**RFB-2024-65**  
**SUNY SCCC CST BUILDING LOBBY AND BATHROOM RENOVATIONS**  
**C2 DESIGN GROUP**

**ADDENDUM #1**

Issued Date: 12/5/2024

6 Stepped Seating Detail  
SCALE: 1" = 1'-0"

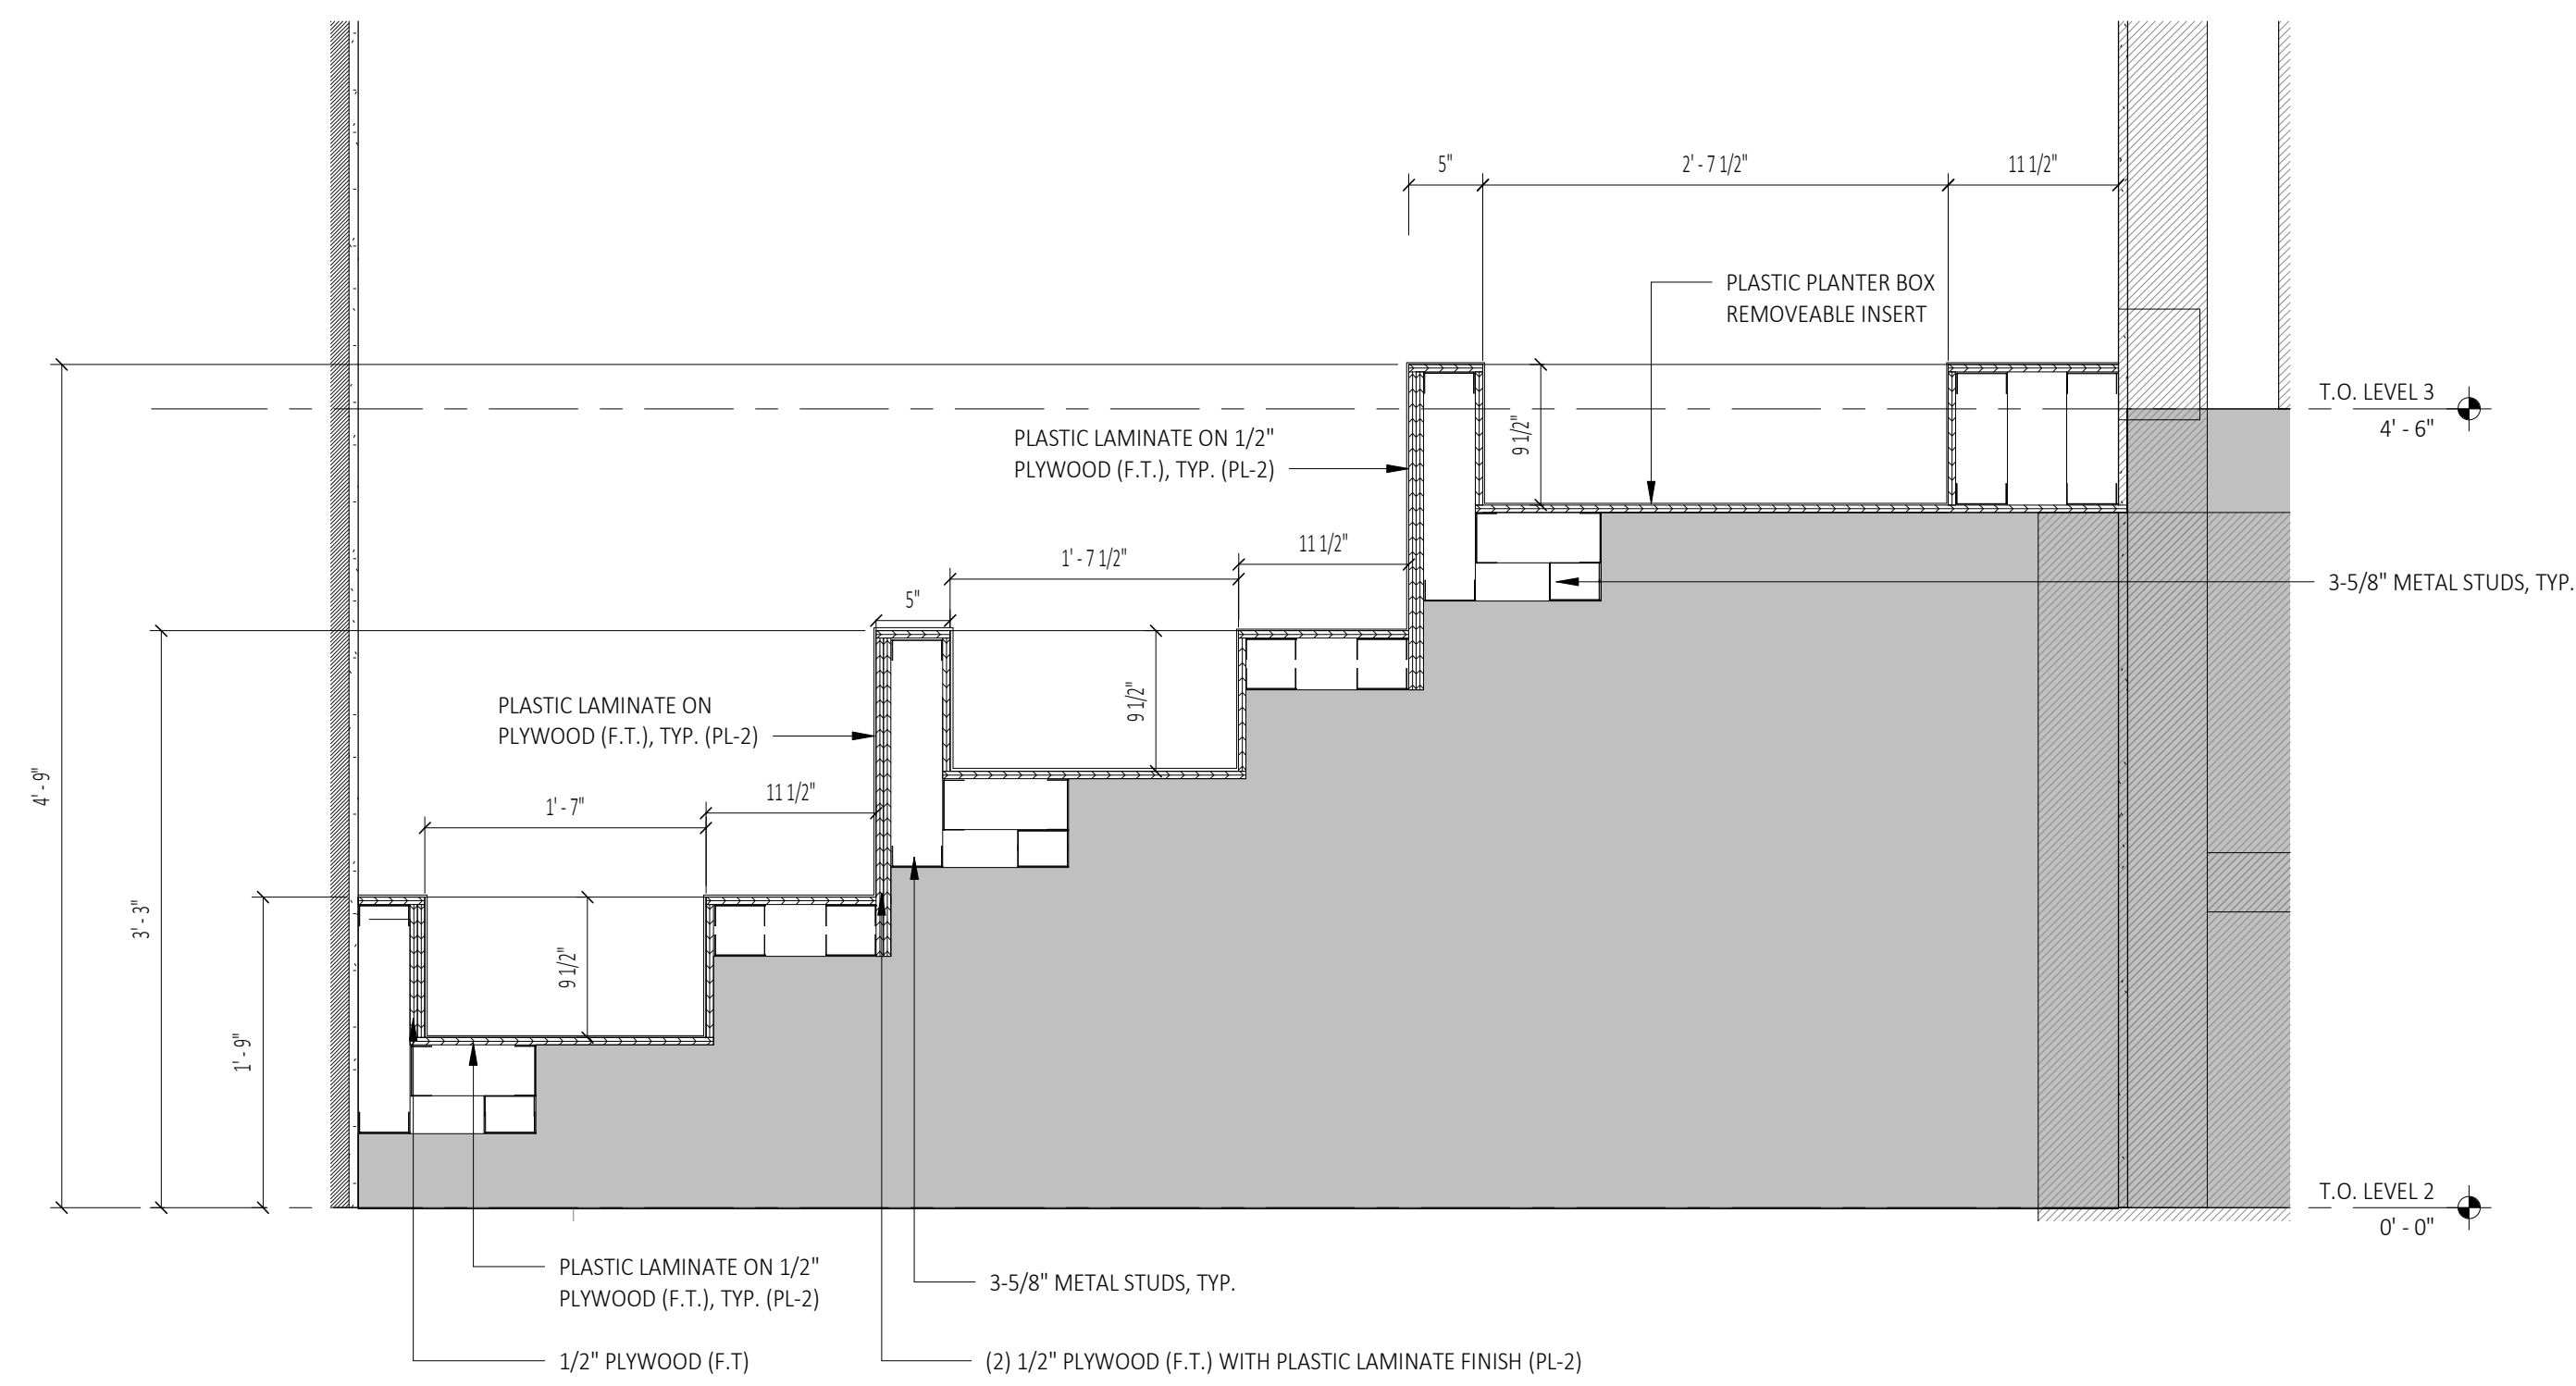
5. Drawing A104 – Roof Plan and Details
  - a. Revisions as marked Addendum #1
6. Drawing A200 – Building Elevations
  - a. Revisions as marked Addendum #1
7. Drawing A400 – Stair Sections
  - a. Revisions as marked Addendum #1
8. Drawing A500 – Exterior Details
  - a. Revisions as marked Addendum #1
9. Drawing A701 – Interior Elevations
  - a. Revisions as marked Addendum #1
10. Drawing A900 – Schedules
  - a. Revisions as marked Addendum #1
11. Specifications 08 41 13 – Aluminum Storefront Systems
12. Specifications 08 71 00 – Door Hardware

INTERIOR ELEVATIONS  
Sheet Number:  
**A701**

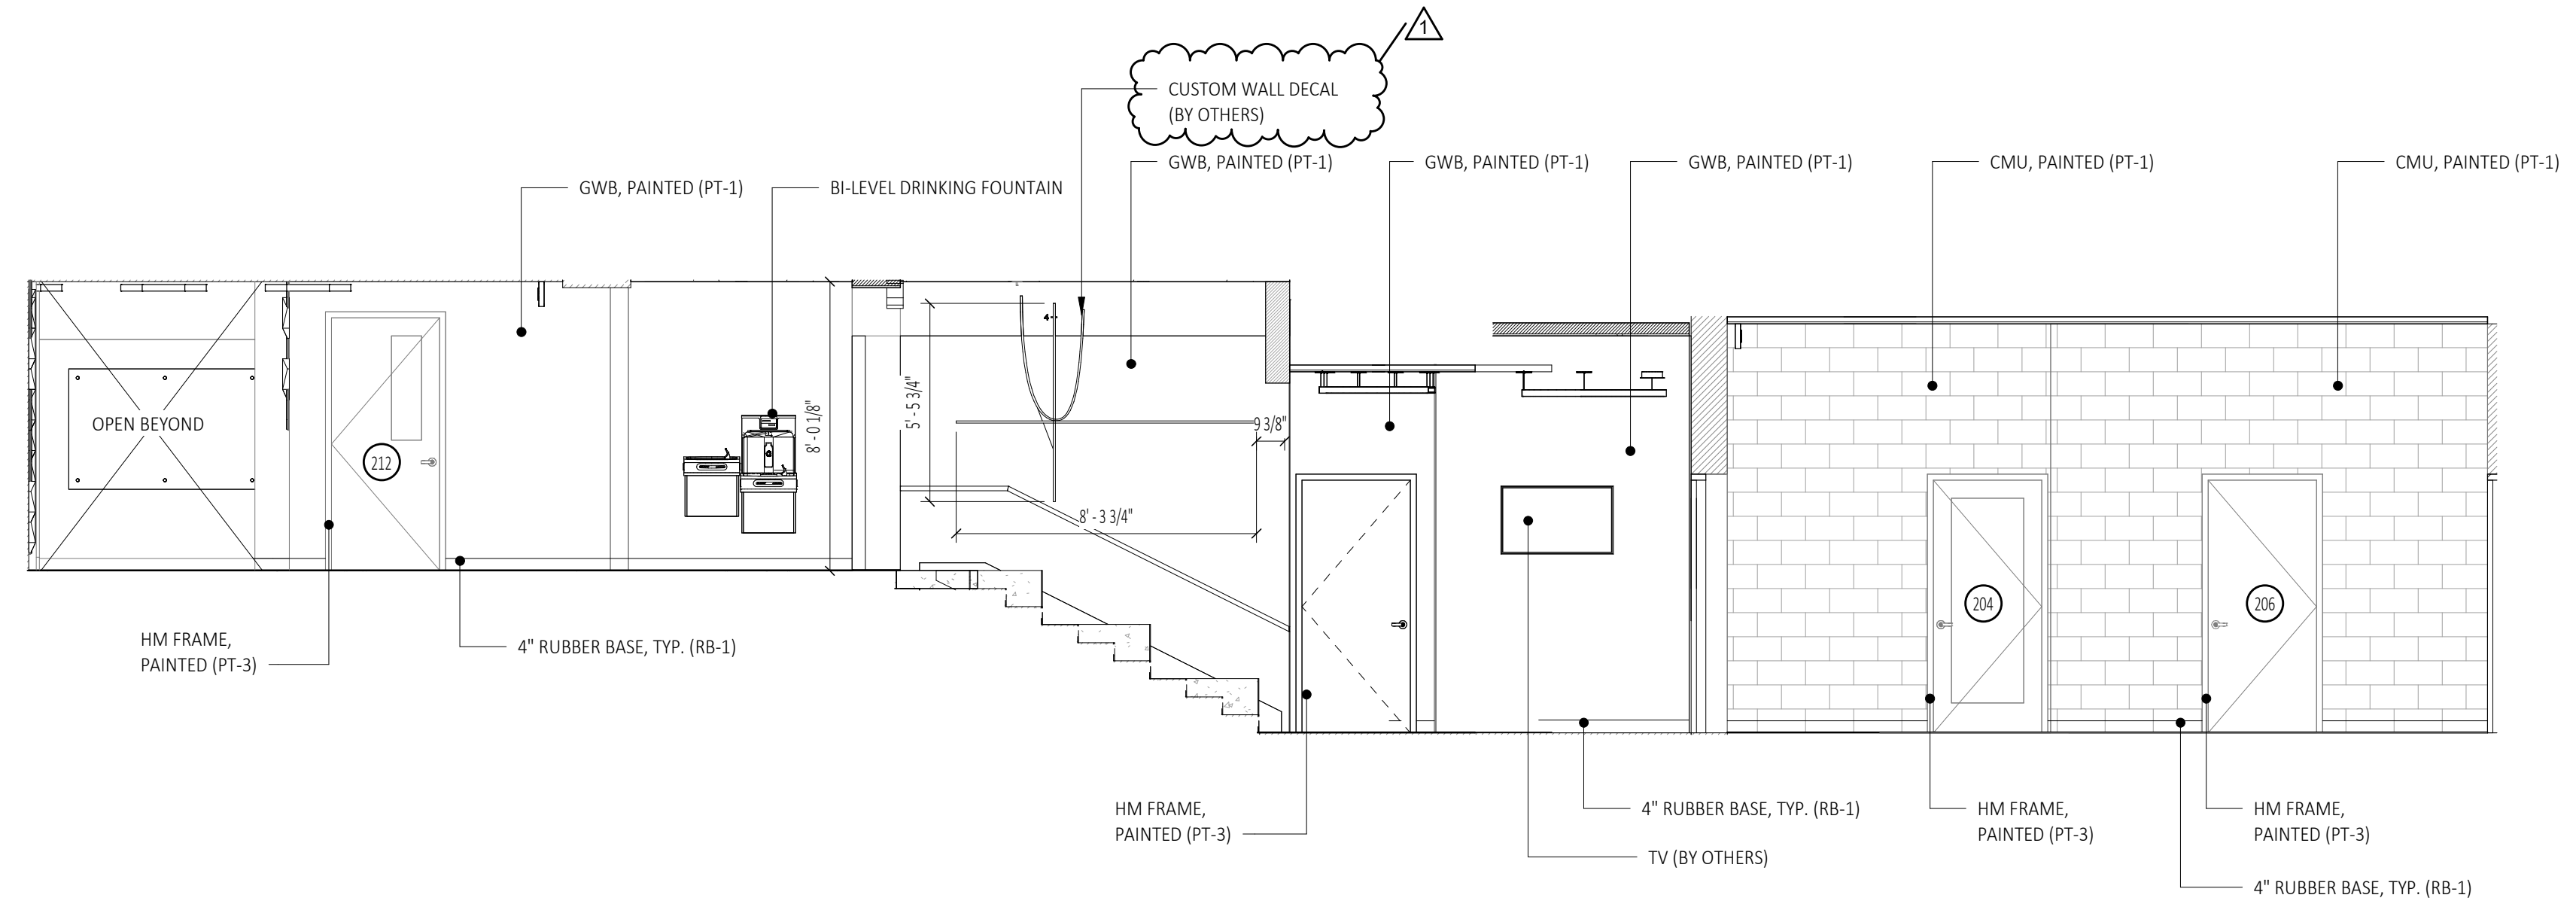
1. Drawing A901, Finish legend calls out two different Types for exterior metal wall panels (EMP-1 & EMP-2) but the drawing only shows “metal panel”. Please clarify?
  - a. Response: See Drawings A200 & A701 Addendum#1
